TENNESSEE VALLEY AUTHORITY  
BROWNS FERRY NUCLEAR PLANT (BFN)  
UNITS 1, 2, AND 3

PROPOSED TECHNICAL SPECIFICATION (TS) CHANGE TS-339  
MARKED PAGES

PROPOSED TECHNICAL SPECIFICATION (TS) CHANGE TS-339  
REVISED PAGES

APRM FLOW BIAS SCRAM Vs. REACTOR CORE FLOW  
Fig. 2.1-2

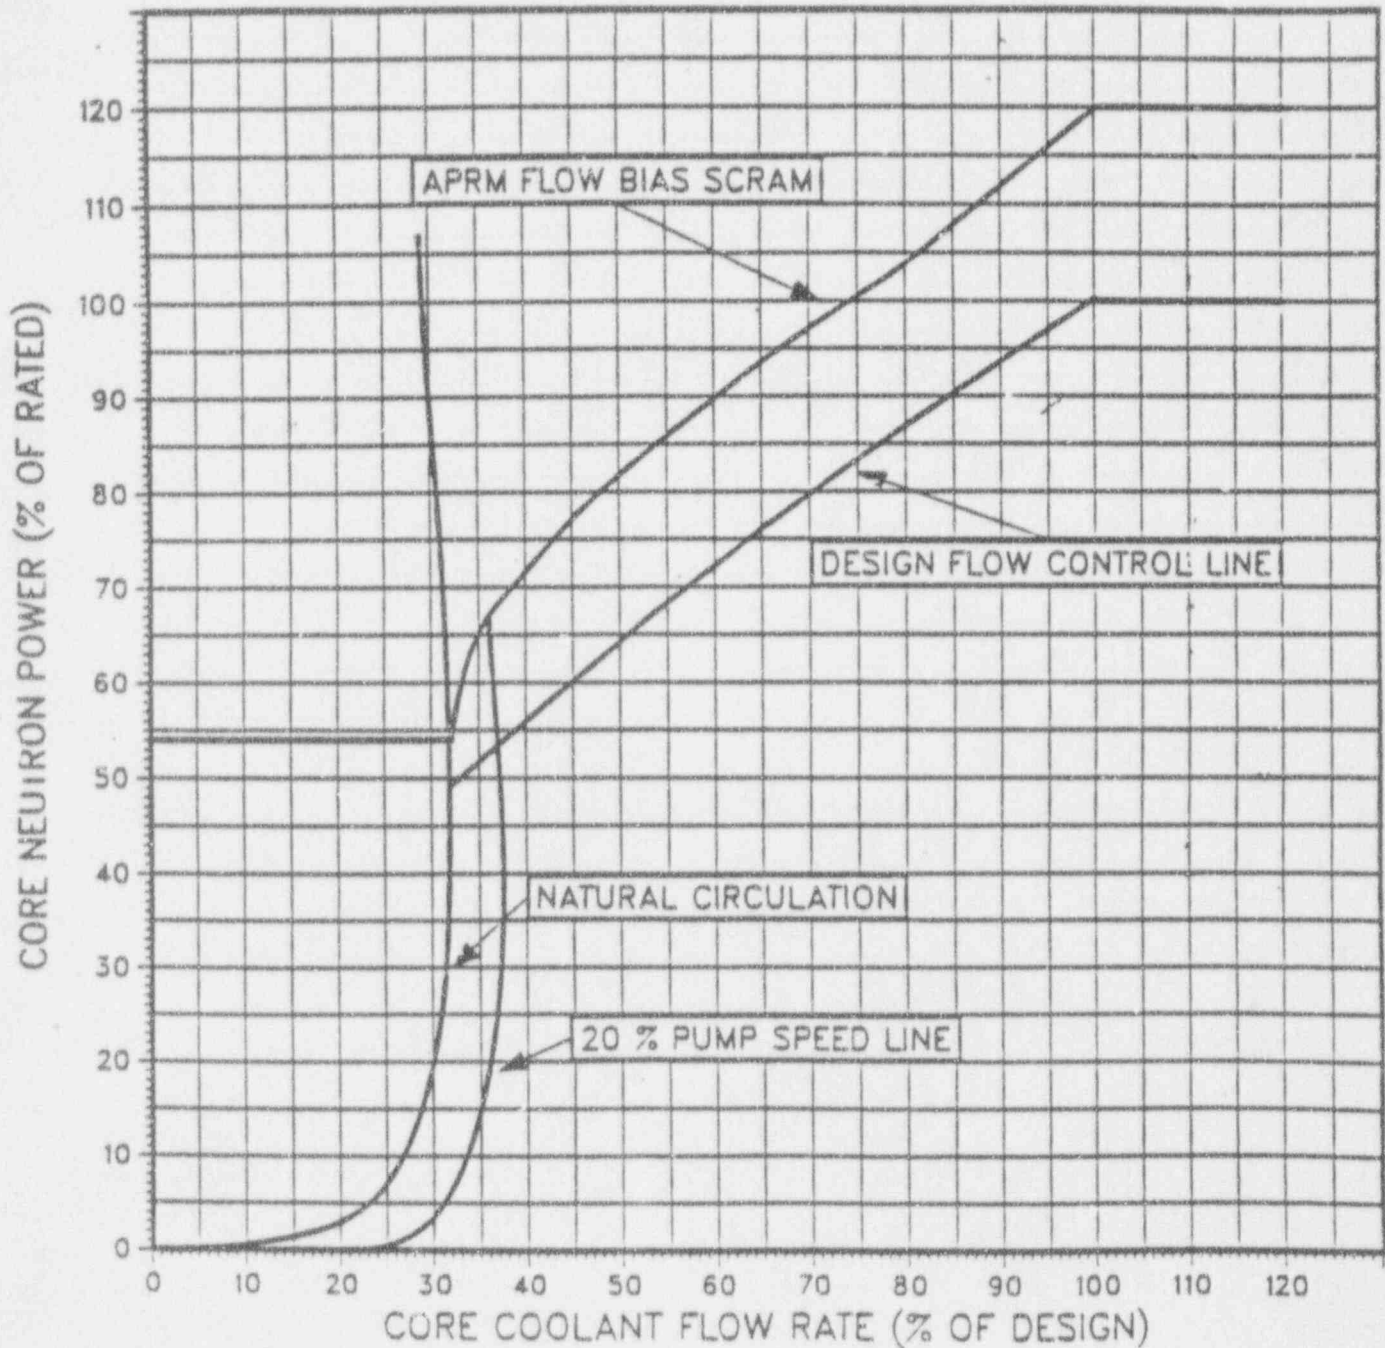
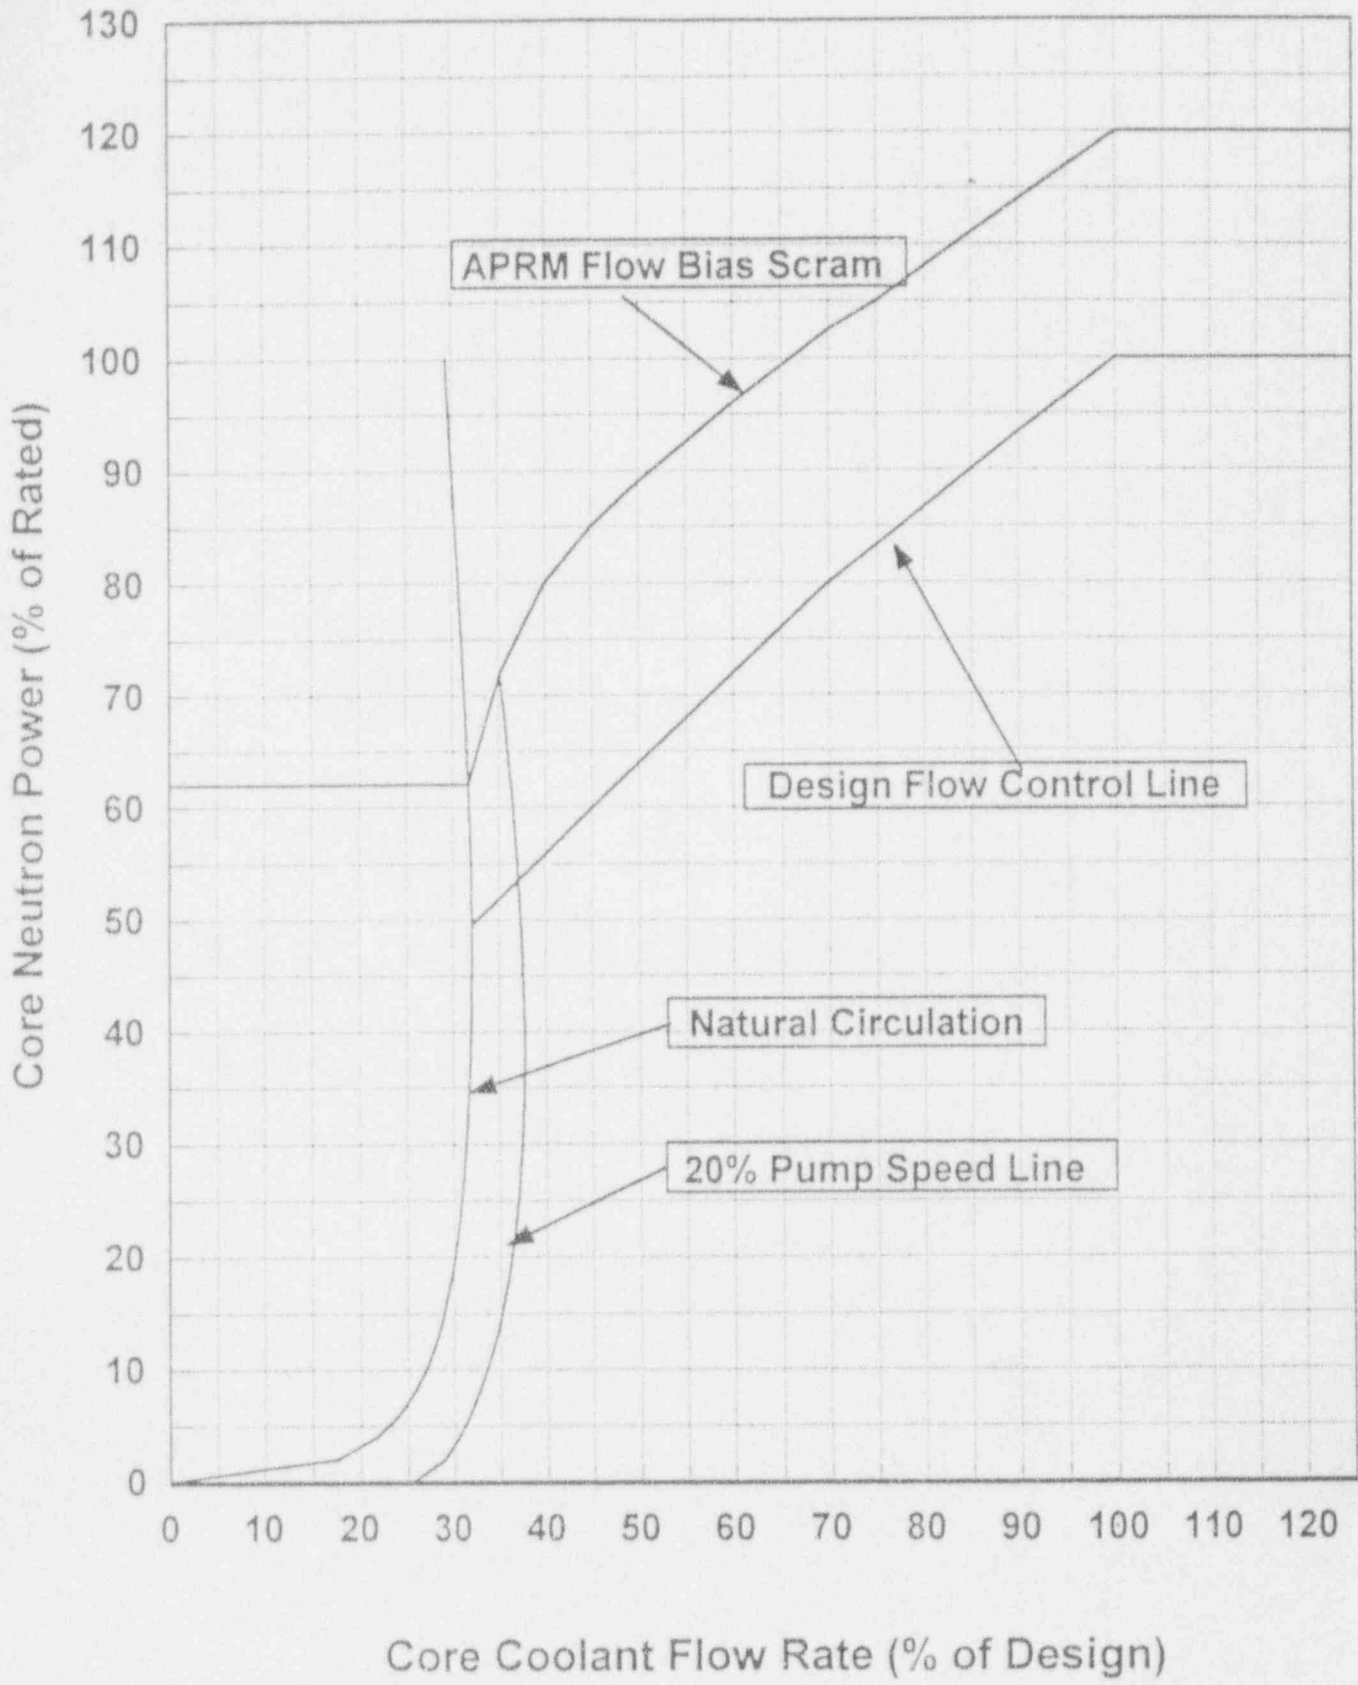
DELETE THIS FIGURE

REPLACE THIS FIGURE WITH NEW  
FIGURE ON FOLLOWING PAGE

Figure 2.1-1

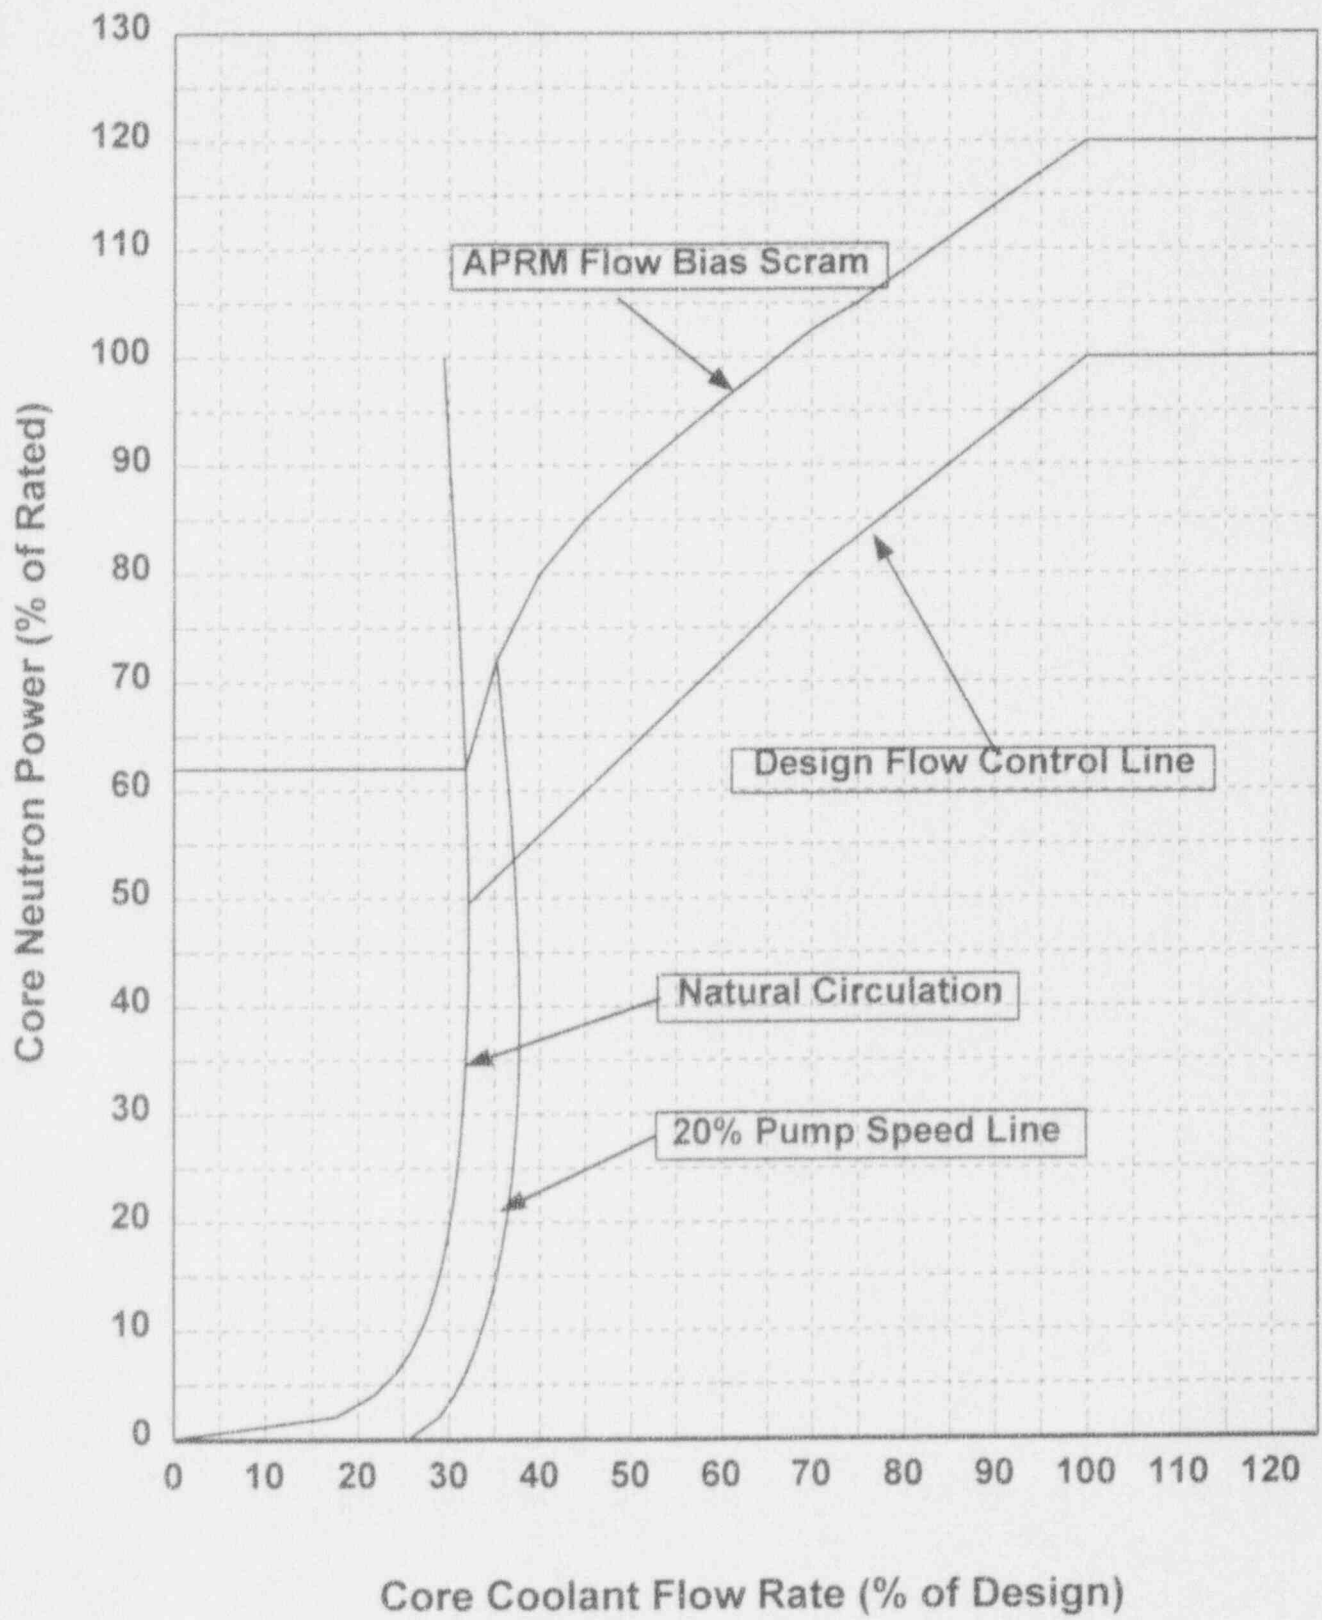
DELETED

- c. The APRM Rod Block trip setting shall be less than or equal to the limit specified in the CORE OPERATING LIMITS REPORT.

Figure 2.1-1

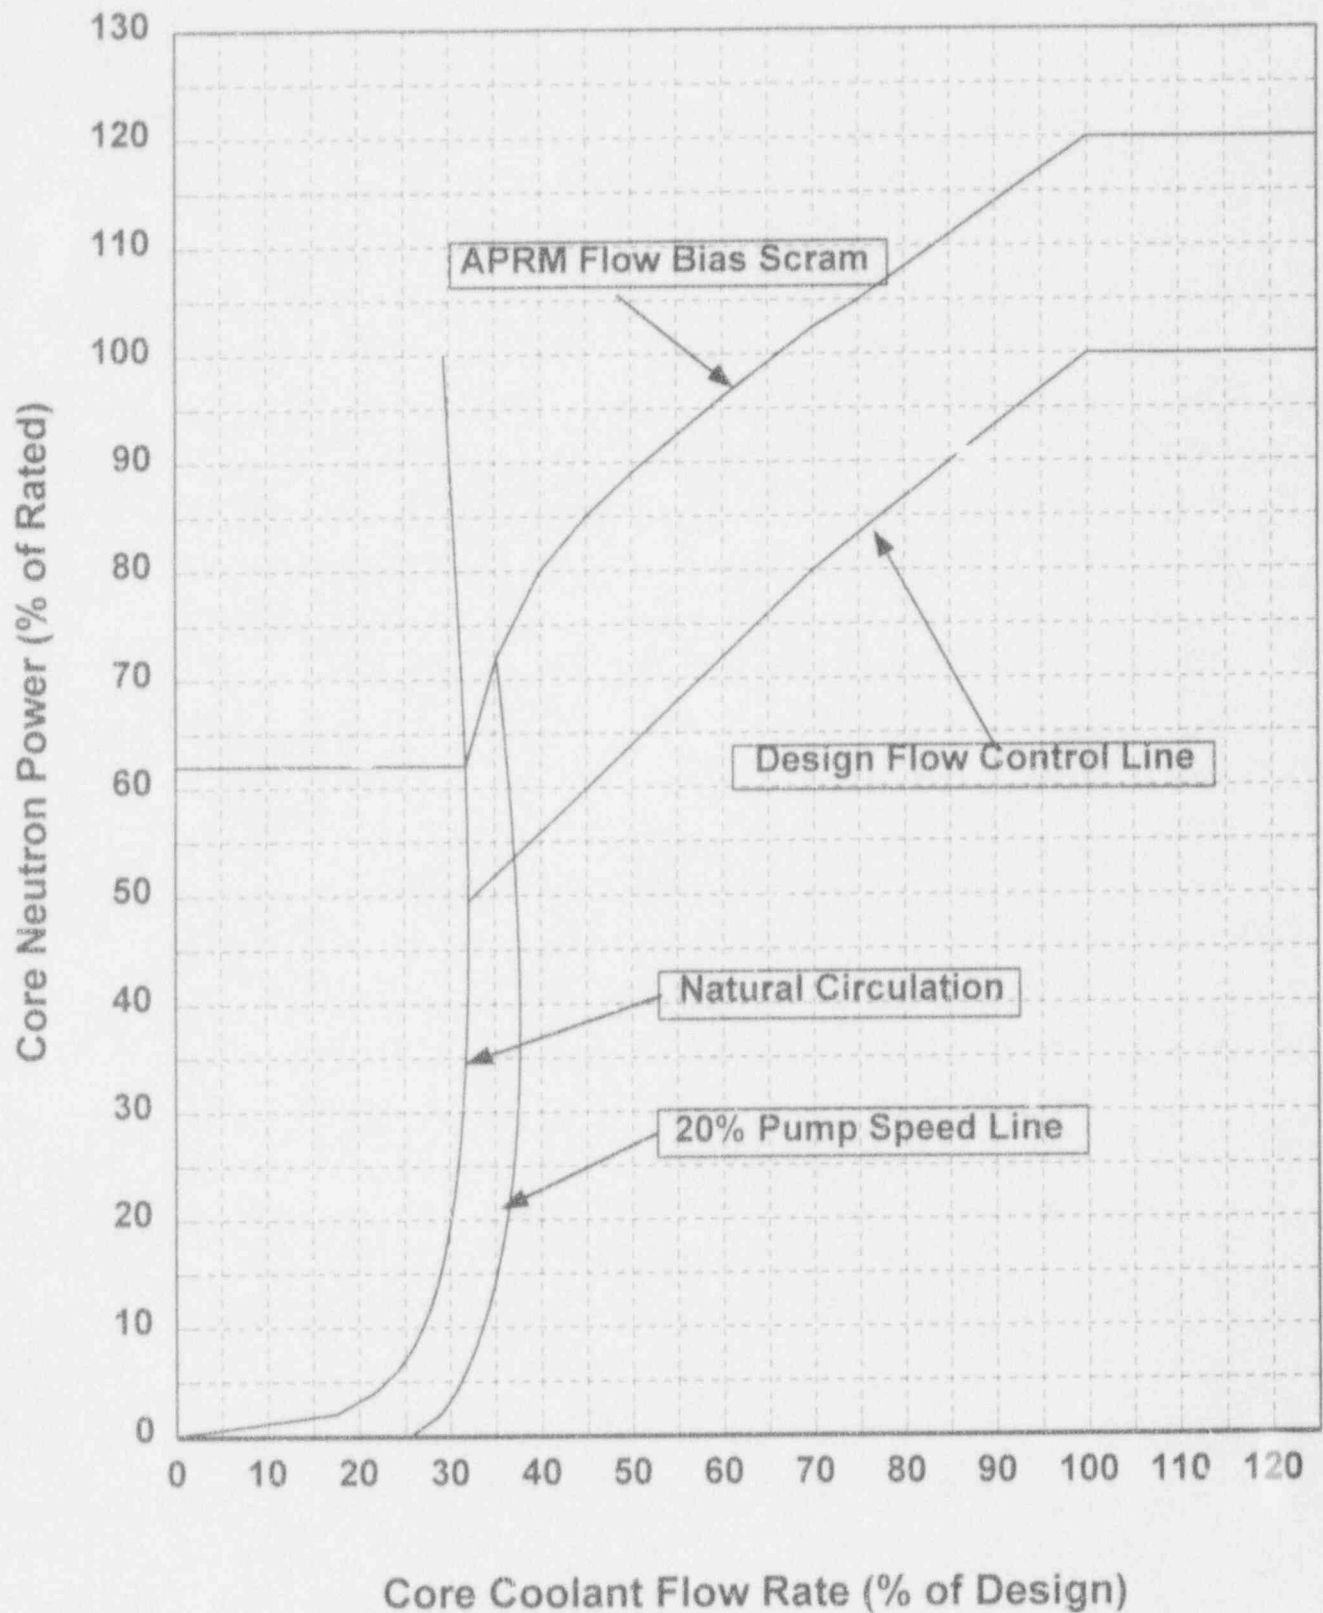
DELETED

- c. The APRM Rod Block trip setting shall be less than or equal to the limit specified in the CORE OPERATING LIMITS REPORT.
